RE: Amendment for USA/9296/B(U)-96

Enclosed please find an application for amendment to the Type B(U) approval of the Model 880 Series transport packages. The application addresses a change to the descriptive drawing for these package, R88000 Revision J (copy enclosed). This revision incorporates an alternative length for the lock screws specified on Sheet 3 of 5 of the drawing. This allows the currently approved screw (#10-32 x 1 1/4" long) as well as an alternative screw (#10-32 x 1 3/16" long).

DESCRIPTIVE DRAWING

TITLE MODEL 880 PROJECTOR

LOCK DETAIL
SOURCE ASSEMBLY SECURED POSITION

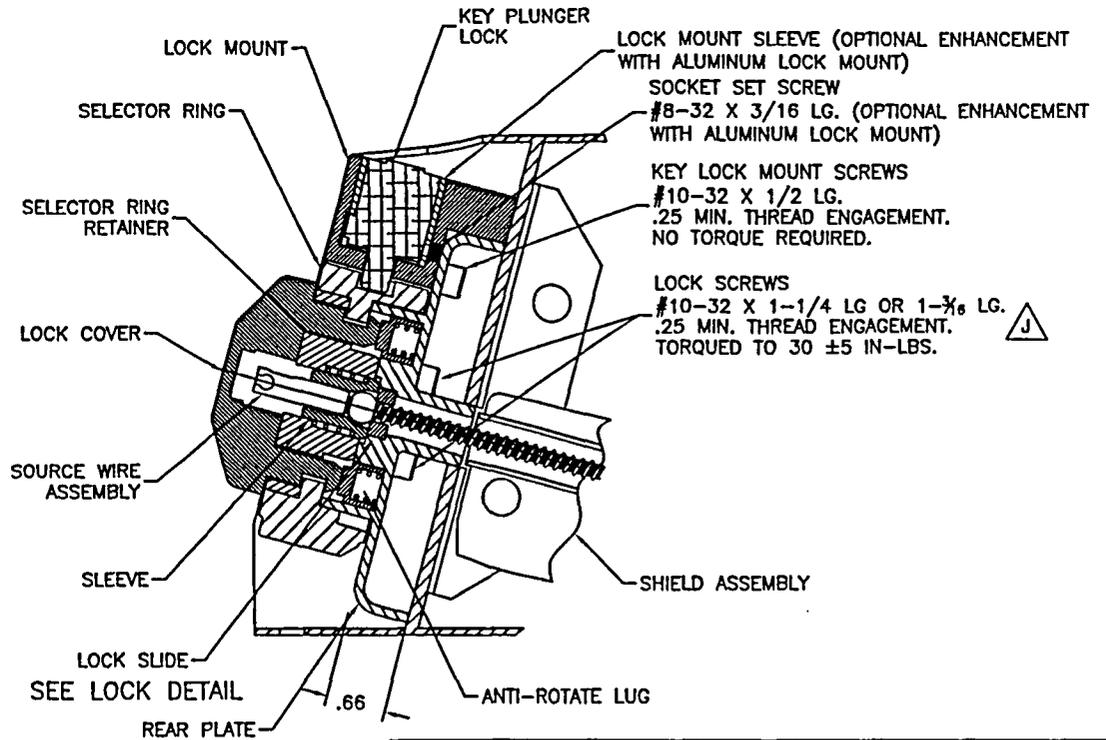
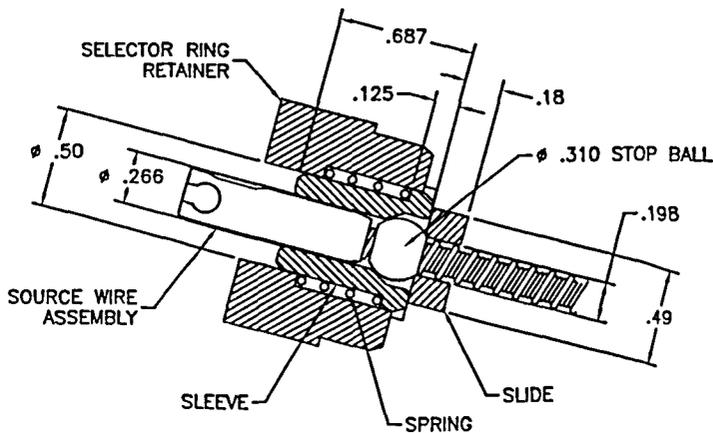
The current screw allows an extra 0.02 inch screw protrusion from the selector ring retainer and elimination of this protrusion does not affect the safety aspects of the loc assembly or any other area of the device. Further, both the current and proposed alternative screws meet the minimum 0.25 inch thread engagement requirement specified on the drawing, therefore there will be no loss of safety related to this optional change.
